ADDENDUM NO. 2
A New Housing Unit for Newberry County Detention Center
Newberry, South Carolina
Newberry County Government
July 23, 2025

Construction Documents for the above project are hereby amended as follows:

S2.2

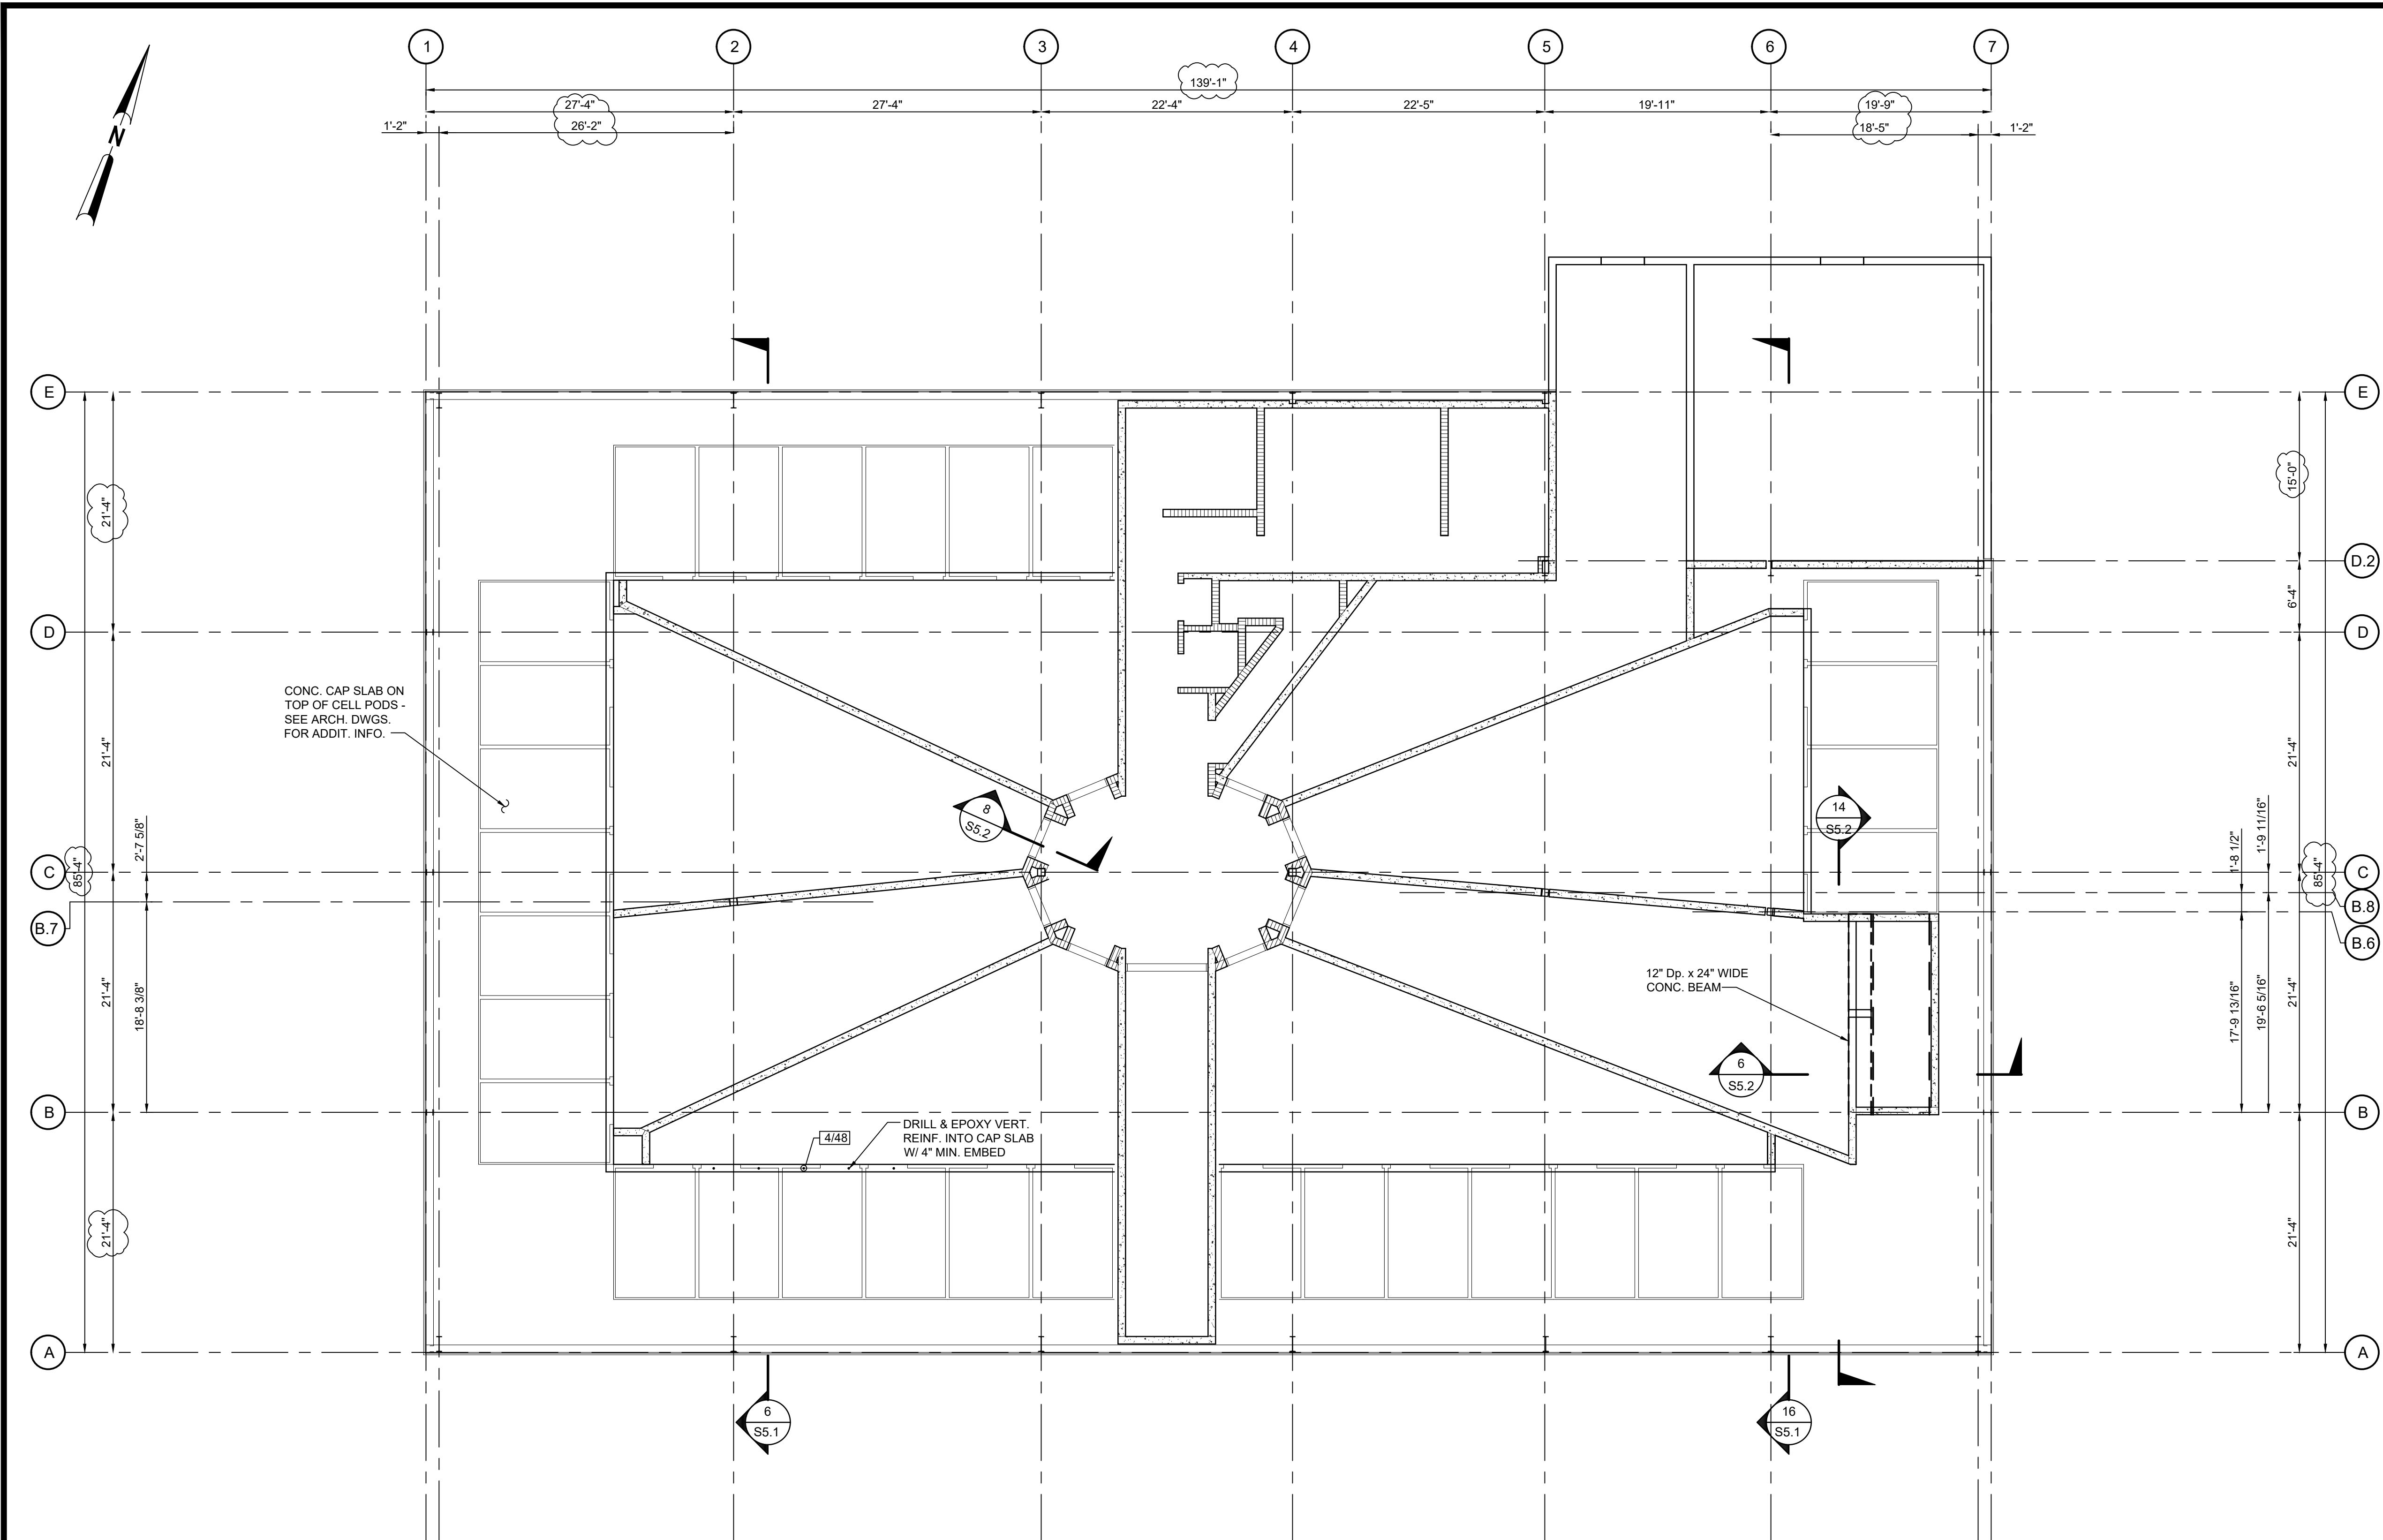
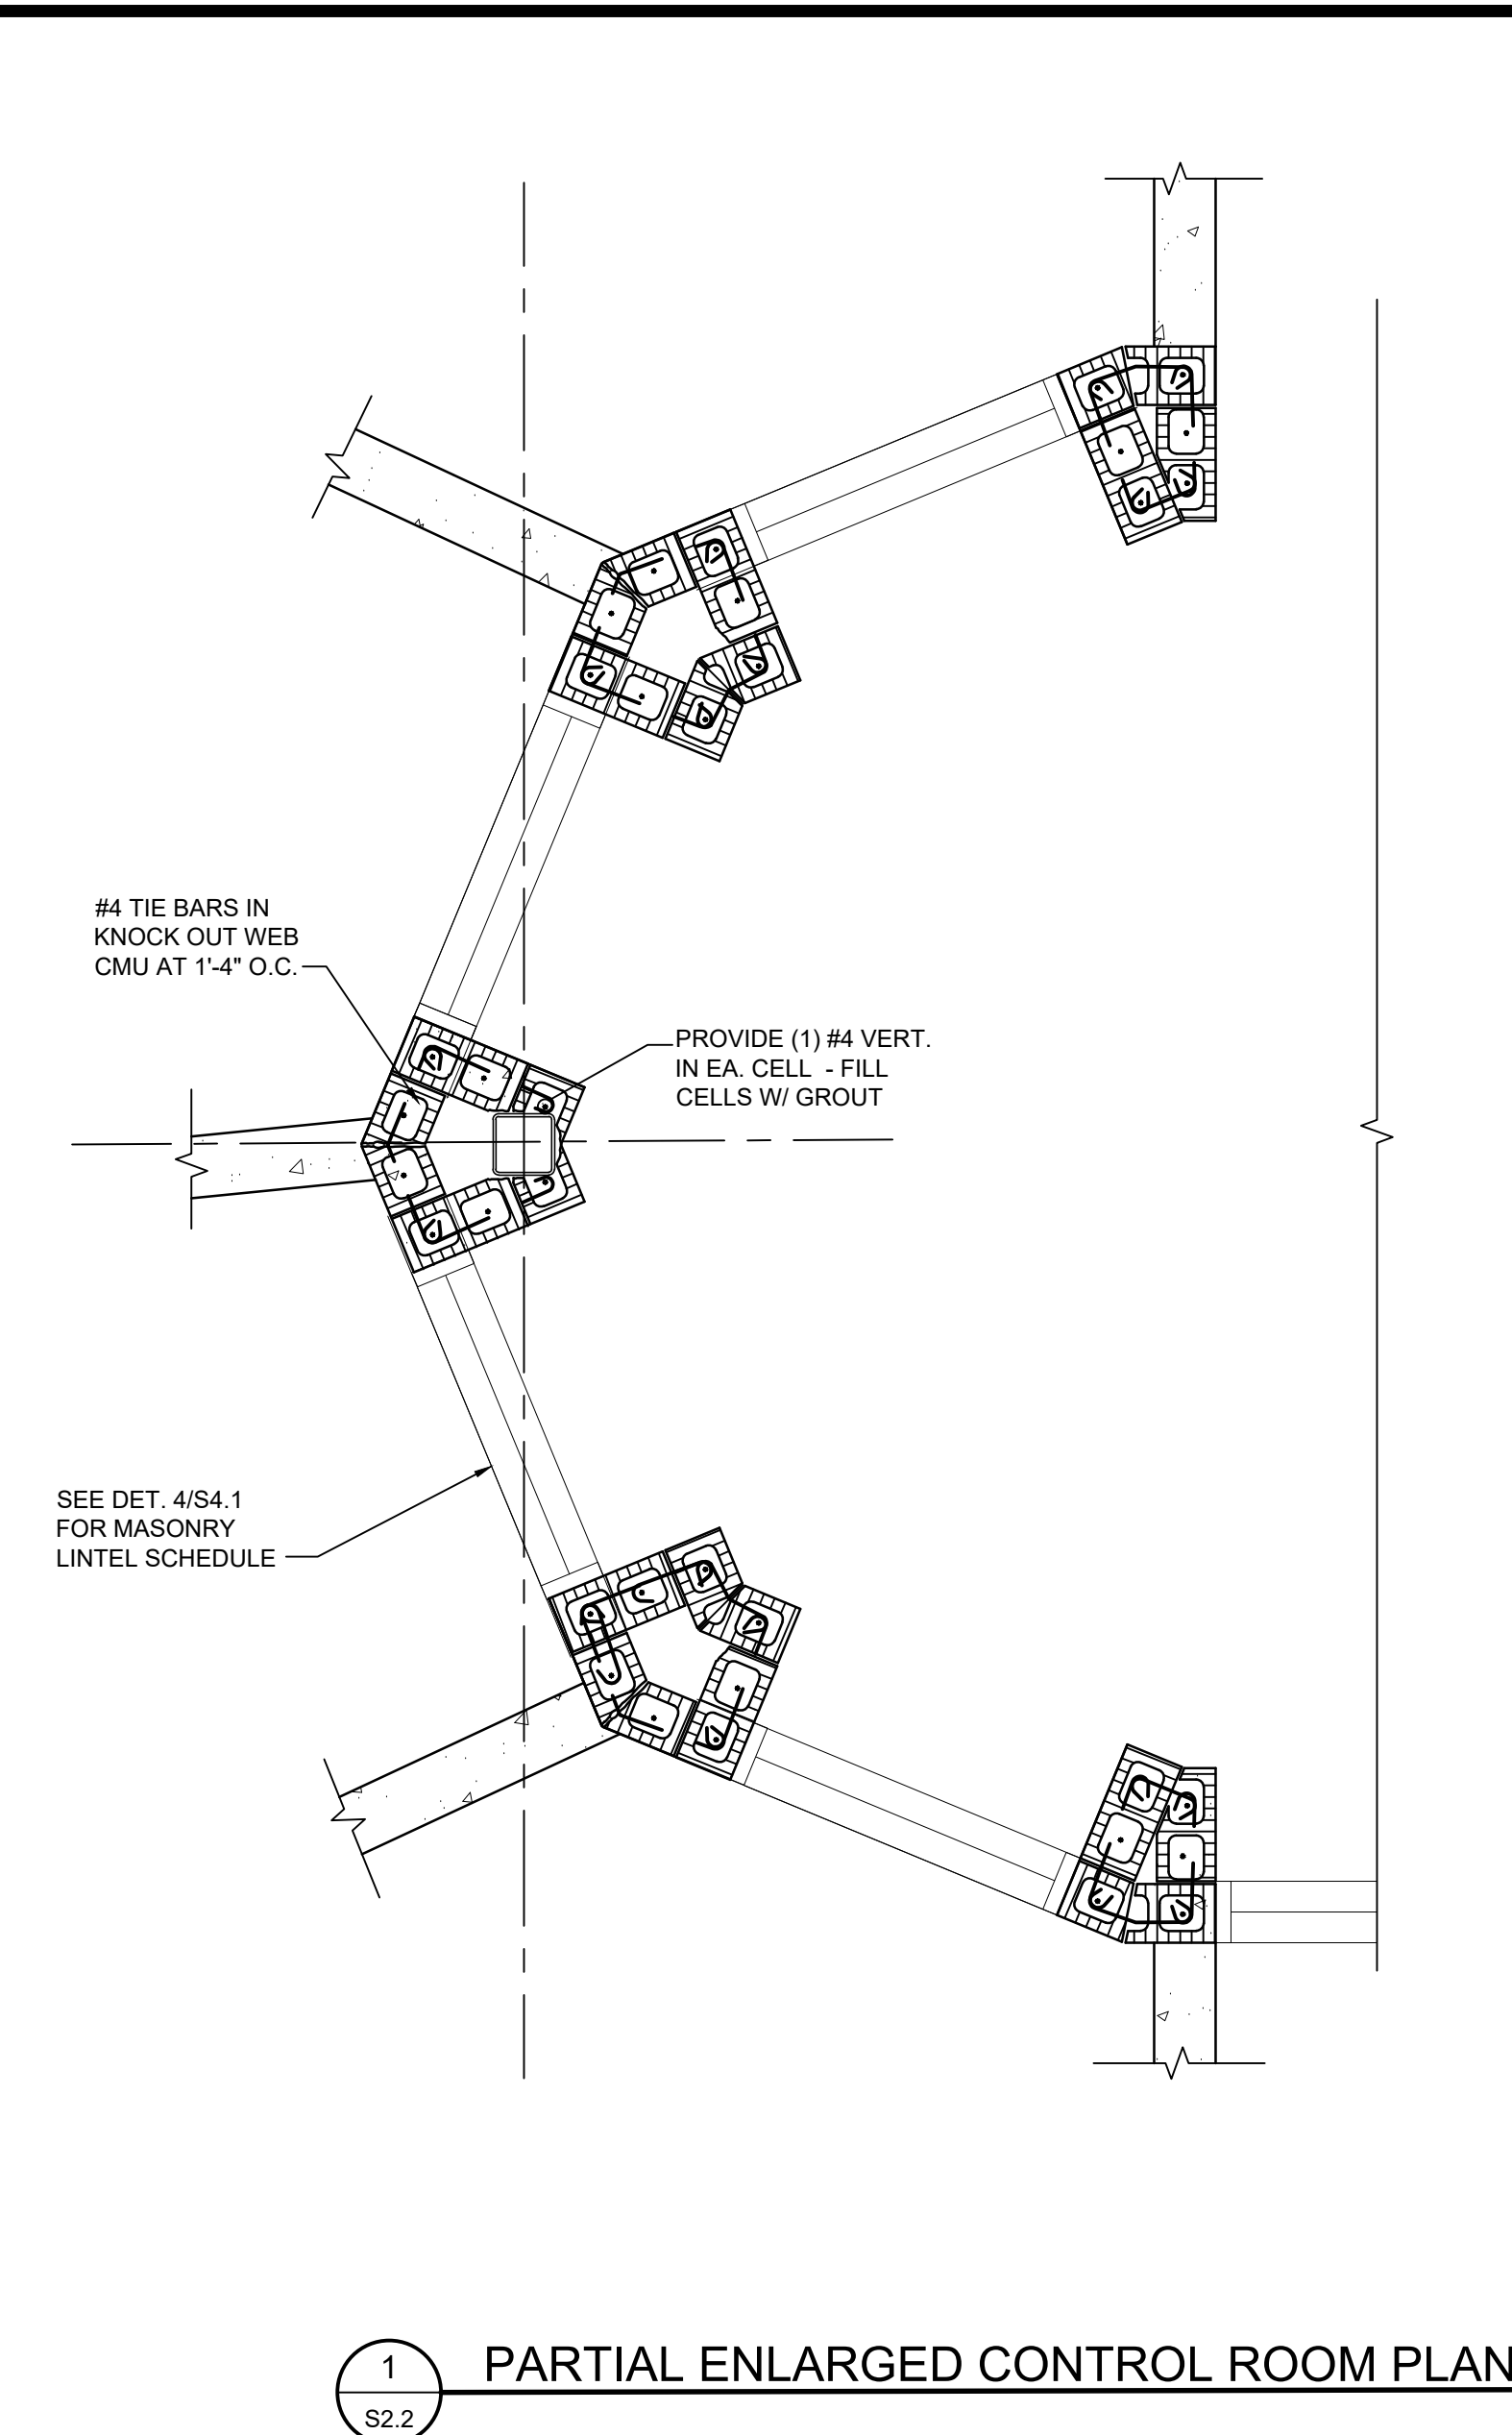
21. Sections 6, 11 & 14 appear to show additional concrete beams at the concrete ceiling areas beyond what is noted on the plans on S2.2 and S2.3 but dimensions are not noted and scaled dimensions are inconsistent. Are any additional concrete beams required other than the 12"x24" and 12"x12" beams noted on S2.2 and S2.3? If so, please provide locations, dimensions and reinforcing information.
Only beams shown are required.

34. Sheet S2.2 notes “concrete topping slab over steel plate cell floor, see arch. Dwgs for info & requirements”. The architectural plans do not provide any information regarding concrete topping at cells. Please provide a plan that shows required locations as well as concrete thickness and reinforcing (if any).
Disregard note. Concrete topping is not required.
